### STAFF REPORT FOR THE PLANNING COMMISSION

FILE NUMBER:	SUB-18-04/WAP-18-05
HEARING DATE:	August 21, 2019
REQUEST:	12-lot Subdivision at 22870 Weatherhill Road
APPROVAL CRITERIA:	Community Development Code (CDC) Chapter 12, Single-Family Residential Detached and Attached, R-7; Chapter 32, Water Resource Area Protection; Chapter 48, Access, Egress and Circulation; Chapter 55, Design Review; Chapter 85 Land Division General Provisions; Chapter 92, Required Improvements.
STAFF REPORT PREPARED BY:	Jennifer Arnold, Associate Planner

# ADDENDUM PLANNING COMMISSION STAFF REPORT August 21, 2019

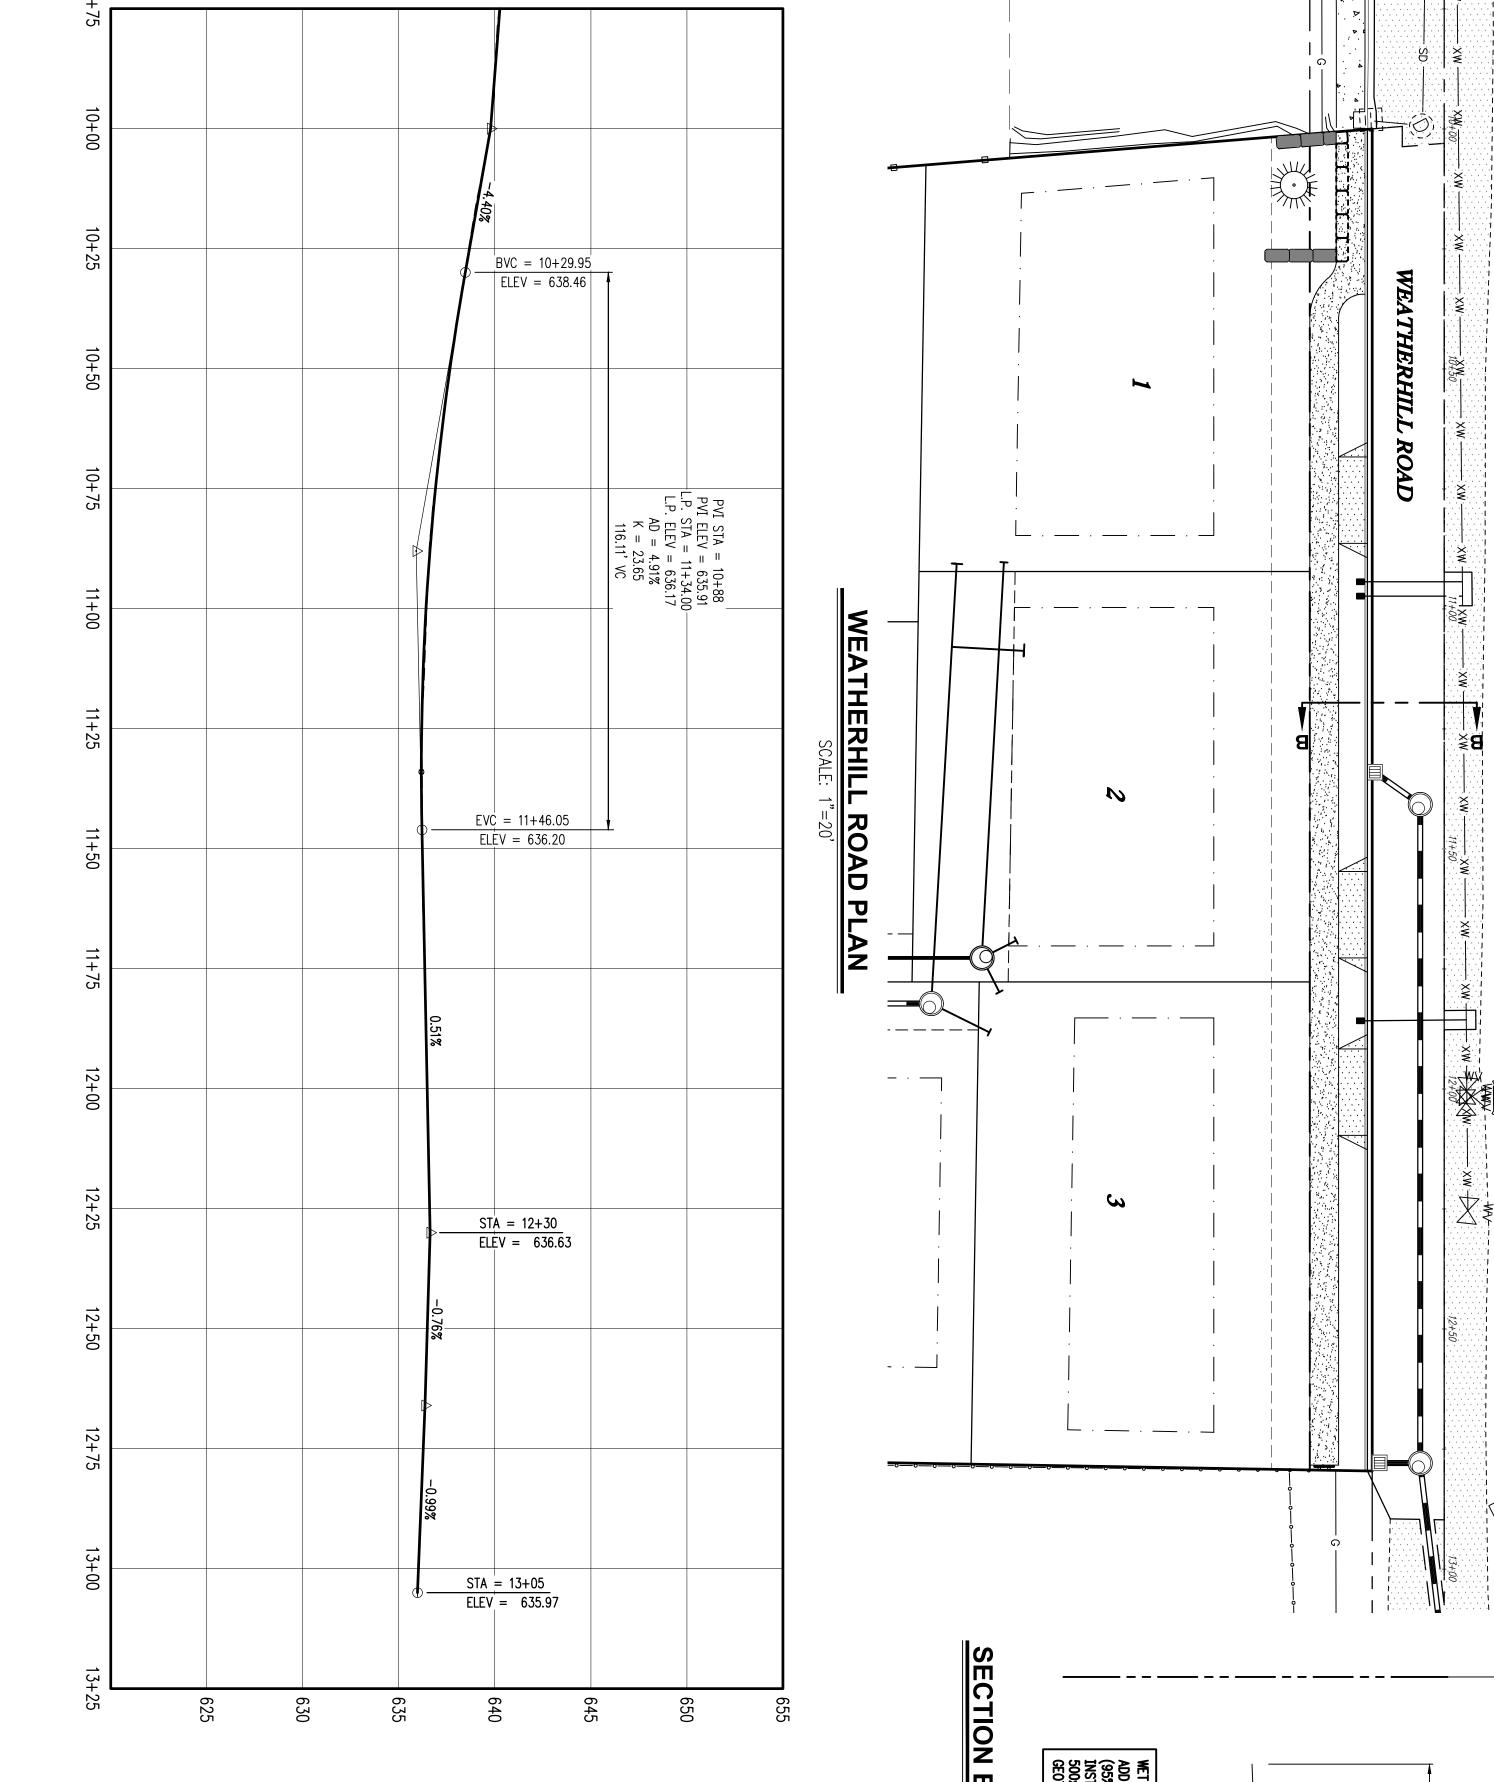
Staff Finding 17: The applicant proposes to provide access to Weatherhill Road (lots 1, 2, and 3) and Satter Street (lots 4-12). The applicant shows a shared curb cut for lots 6 and 7 on sheet 7/13. Proposed lot 6 is a flag lot with 19.8 feet of street frontage on Satter Street. This criterion is met.

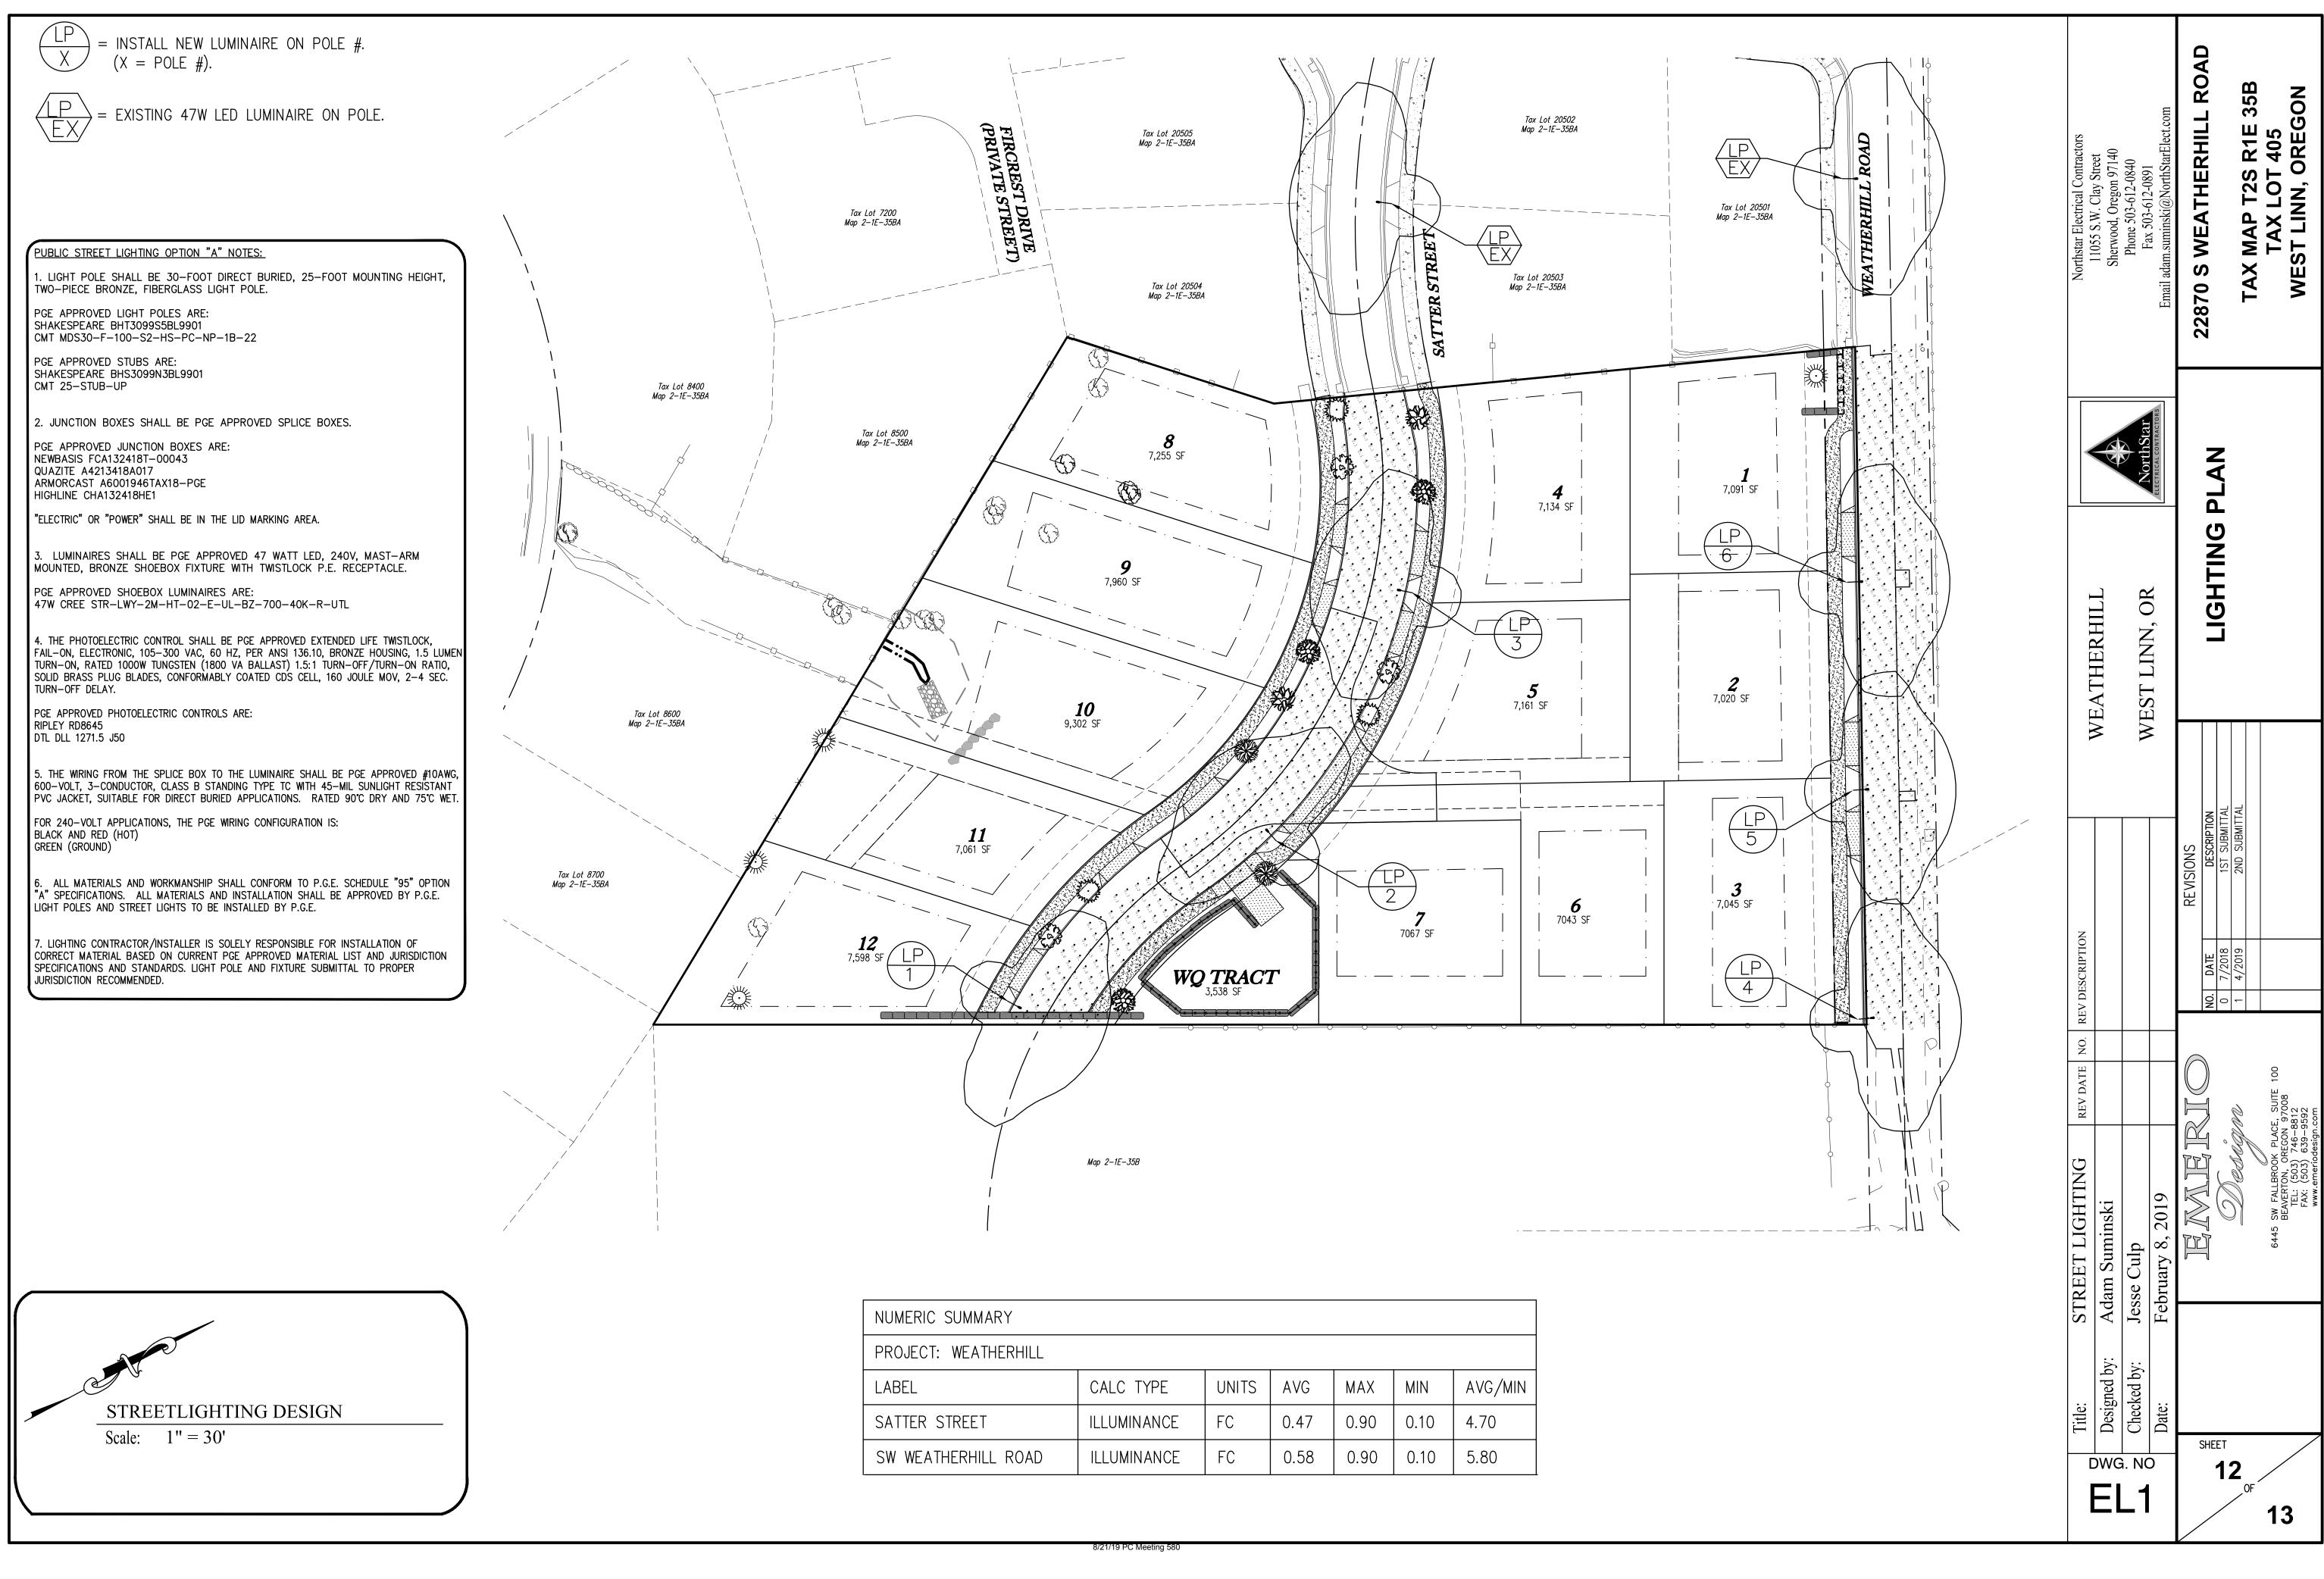
Staff Finding 32: The Sewer Master Plan has confirmed that there is sufficient sanitary system and sewage treatment facility capacity. The applicant proposes to connect with the existing sewer line in the Crestview Drive right-of-way to serve all proposed lots (See 'Composite Utility Plan' sheet 11/13 of the applicant's submittal). The applicant shall record a

Staff Finding 34: An 8 foot public utility easement shall be recorded on the face of the plat per condition of approval 2 along all lot frontages. The applicant shows these easements on sheet 11/13 'Composite Utility Plan'. In addition, the applicant shall record a sewer easement to extend the existing sewer line in the Crestview Drive right-of-way through a City owned tract to serve the proposed subdivision per condition of approval 3. Subject to conditions of approval, this criteria is met.

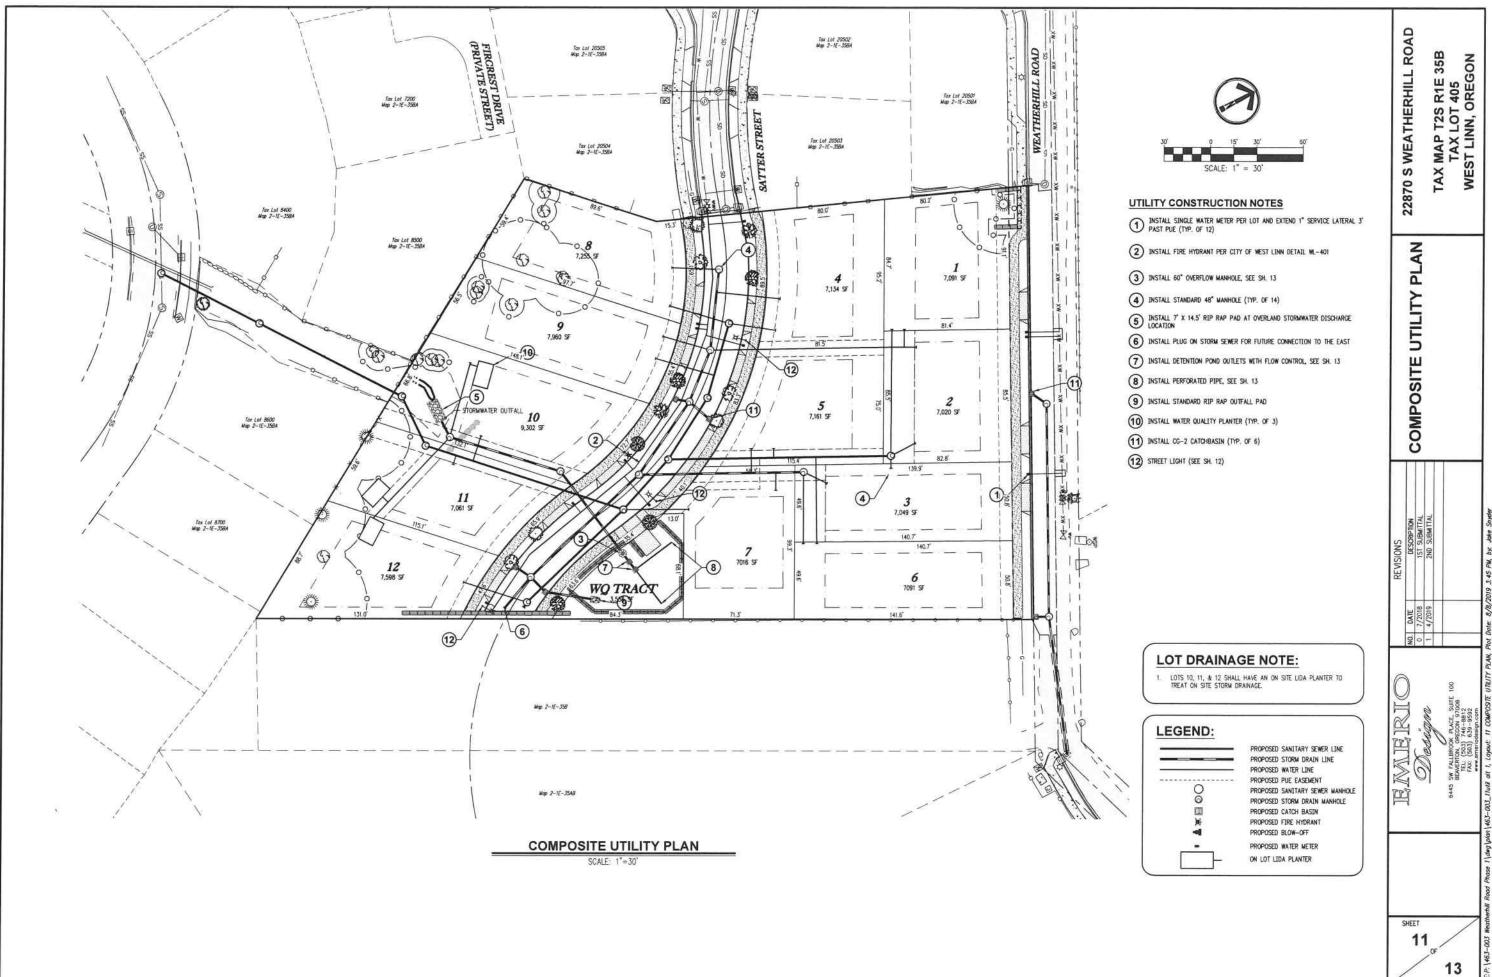
Staff Finding 36: The subject property fronts Weatherhill Road and Satter Street is stubbed to the western property boundary. The applicant proposes to extend the stubbed section of Satter Street on the western property boundary through the subject property and dedicate it as public right-of-way. In addition, the applicant is required to dedicate 13 feet of property to the Weatherhill Road right-of-way for street improvements. These dedications are shown on sheet 6/13 'Preliminary Plat' of the applicant's submittal. This criterion is met.
